Overview: Production error in version 1.0 harnesses; The immobilizer wire (orange/black) is in pin position #4 instead of pin position #5. Although an effort to correct the issue was made, some quantity of harnesses did get shipped before the issue was spotted. We are advising to inspect the harness BLADE connector before attempting to install harness or program the module. This issue is not known to affect the version 2 harnesses, which require no modification.

Overview: Early versions of the FTI-STP1 harness require modification for **automatic transmission (AT)** applications, some of the product was able to be modified before release, but a small quantity was released without modification.

FTI-STP1: Vehicle Coverage and Preparation Notes

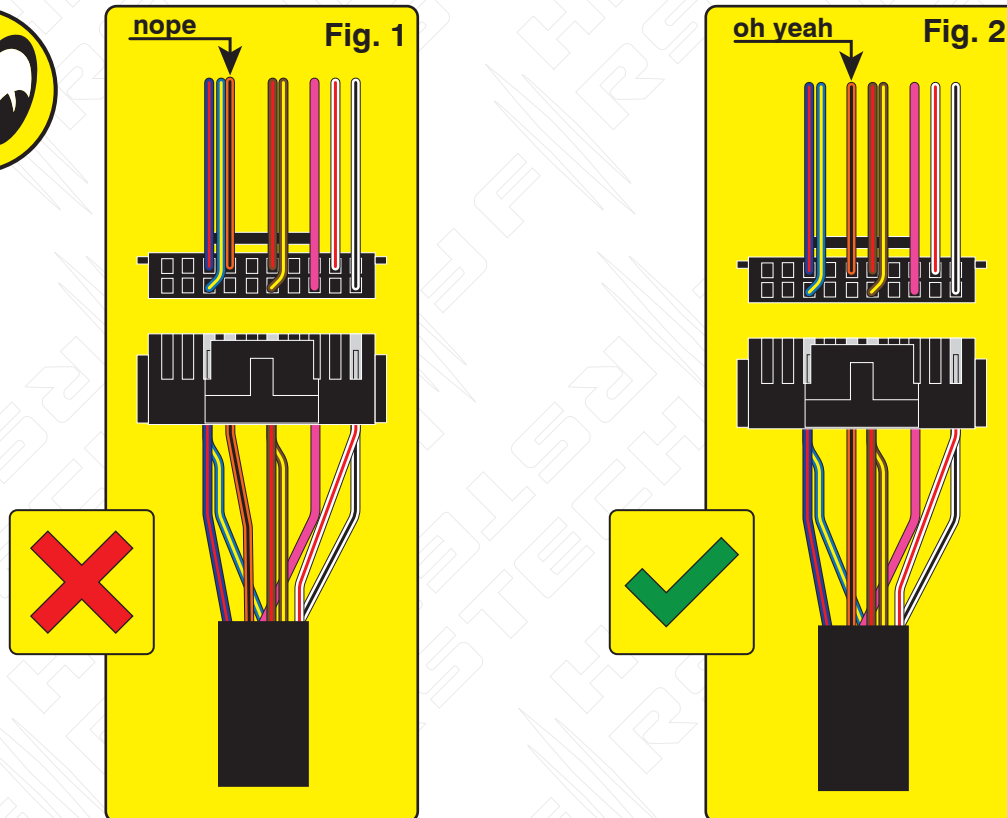
Issue: Module fails to program correctly to vehicle, does not allow the vehicle to be remote started.

Correction: Step 1.) Locate the orange/black wire and confirm whether it is positioned as illustrated in Fig. 1 or Fig. 2. If the wire is as illustrated in Fig.1, proceed with Step 2 through 5 and complete the repair procedure outlined, if the wire is as illustrated in Fig. 2, correction is not necessary, proceed with harness installation and module programming.

Step 2.) Using a pick, lightly depress the catch that secures the terminal in the housing then remove the wire and terminal from the housing.

Step 3.) Using a fine tip razor or utility knife, insert the blade beneath the terminal catch and raise it slightly, so that it can be reused to secure the terminal when reinserted into the BLADE connector housing.

Step 4.) Refer to Fig. 2 for correct position of the orange/black wire (next to brown/red) then reinsert the terminal, pressing lightly until the catch 'snaps' into place, securing the terminal in the connector housing.

Step 5.) The repair is complete, proceed with installation and programming.

MODIFICATION REQUIRED FOR A/T APPLICATIONS, ONLY WITH v 1.0 HARNESS

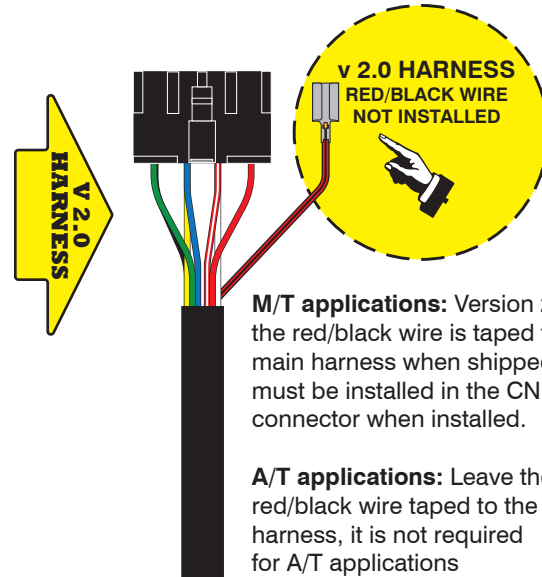
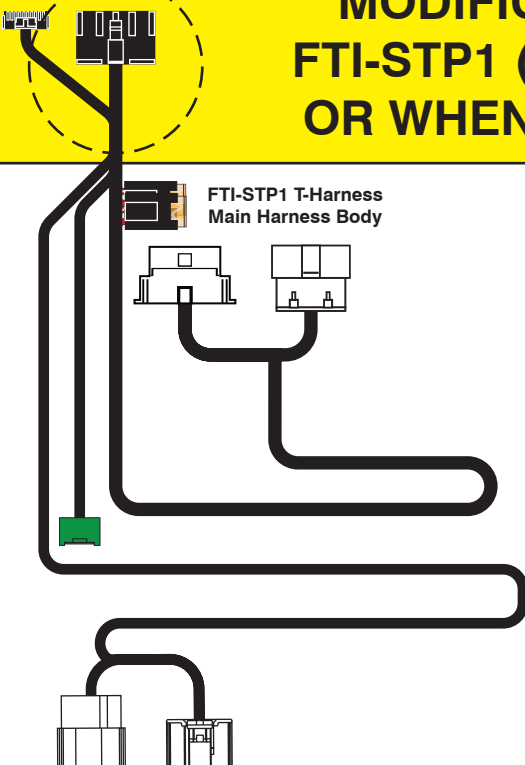
Issue: The FTI-STP1 T-harness has been designed to be compatible with A/T (automatic transmission) & M/T (manual transmission) applications, but due to an oversight in early production runs, the selection was defaulted to M/T mode.

Using a harness configured for an M/T application, in an A/T equipped vehicle, could result in vehicle module damage, it is advised that the harness be returned to A/T mode before installation in vehicles equipped with an automatic transmission.

Correction: Locate the **red/black (+ Clutch)** wire provided in the CN1 connector of the main harness assembly. Cut the **red/black** wire, either flush to the CN1 connector, or leaving enough wire exposed so that you can insulate and secure the ends of the wire that remain after cutting. Insulate each of the remaining ends of the **red/black** wire and secure to prevent any possibility of a short circuit. **If the red/black wire has already been disconnected, no further modification is required for A/T applications**
